Title: **19EB/EF/FA HIGH VOLTAGE MOTOR TERMINALS**Number: **C8803**Date: **2/16/88**Supersedes: **NEW**

Models Affected: **19EB/EF/FA**

Purpose: This bulletin is provided to inform the field of a product improvement regarding high voltage motor terminals.

Fig. 1 - Torque Sequence

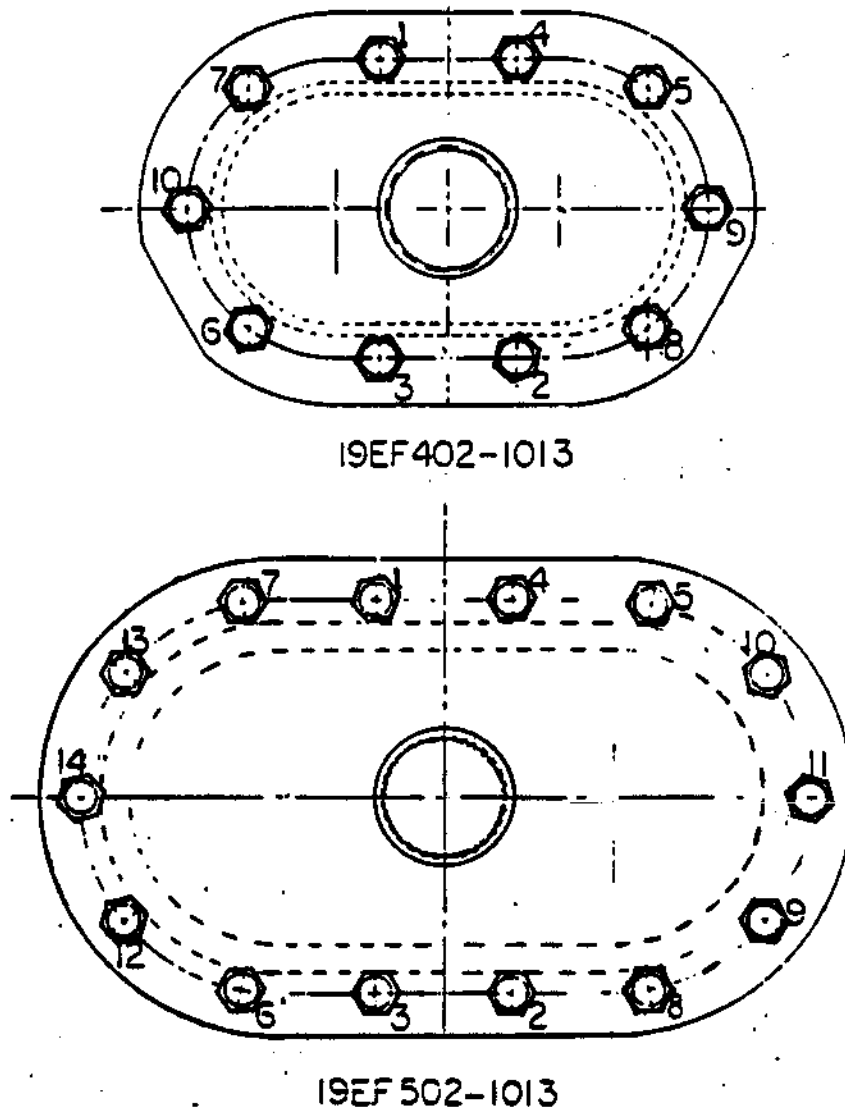
1. Lightly grease quad ring (for terminal board 19EF402-1013) or O-ring (for terminal board 19EF502-1013) and install in terminal board groove. Slide assembly over motor lead.
2. Install terminal board to motor shell bolts and washers and evenly tighten bolts to approximately 5 ft/lbs. Then torque bolts to 12-15 ft/lbs in a sequence as shown in Fig. 1.

Fig. 2 Typical Terminal Arrangements
 19EF402-173 & 19EF502-173
 2400 - 4160 Volts

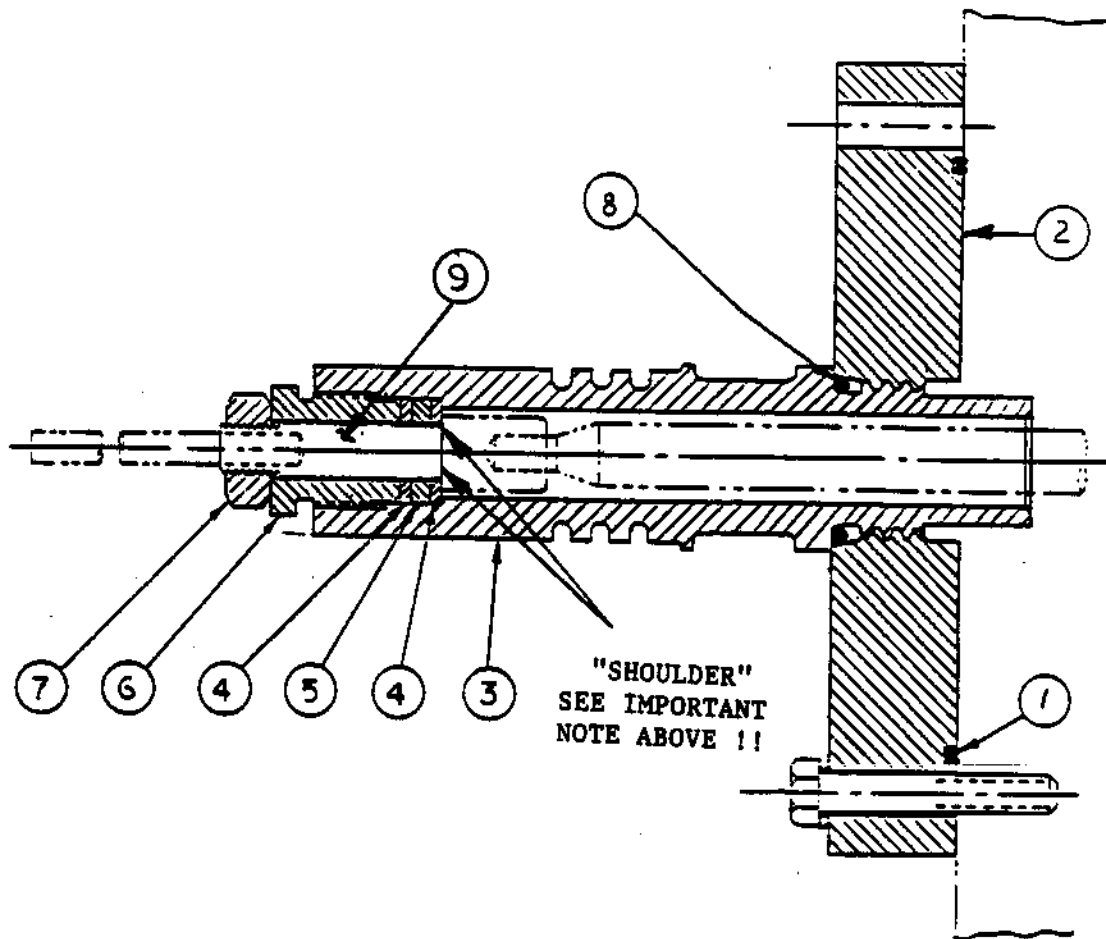
3. Lightly grease insulator O-ring and install on insulator. Lubricate insulator threads and install hand tight in terminal board.
4. Look in end of insulator and check to see if terminal adapter shoulder is flush with step in insulator bore or slightly recessed toward motor (see Fig. 2).

NOTE: Be sure terminal adapter (item 9, "copper") shoulder is flush with shoulder in insulator or slightly back toward motor or packing items 4 and 5 will not seat. Packing nut item 6 will not force the stiff lead wire back toward the motor. If adapter shoulder is out beyond insulator shoulder, the adapter will have to be removed, the wire lead slightly shortened, and the adapter resoldered.

Fig. 3 Typical Terminal Arrangements
19EF402-163 and 19EF502-163
6300 - 690 olts

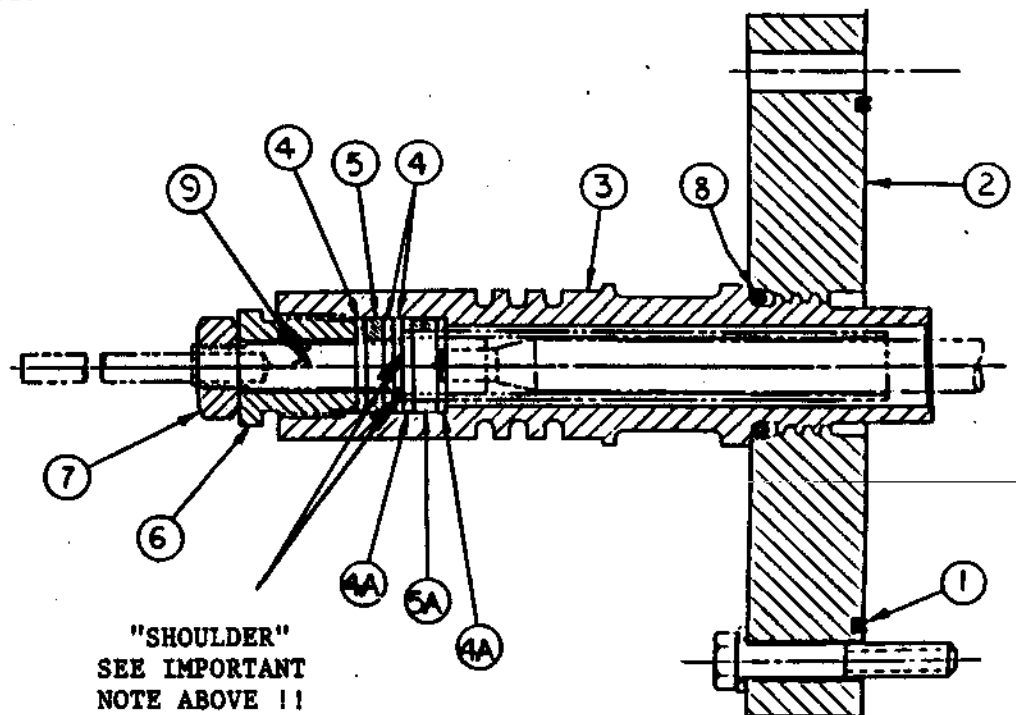
NOTE: Be sure terminal adapter (item 9, "copper") shoulder is flush with terminal retainer 4A or slightly back toward motor or packing items 4, 4A, 5, and 5A will not seat properly. Packing nut item 6 will not force the stiff lead wire back toward the motor. If adapter shoulder is out beyond terminal retainer 4A, the adapter will have to be removed, the wire lead slightly shortened, and the adapter resoldered.
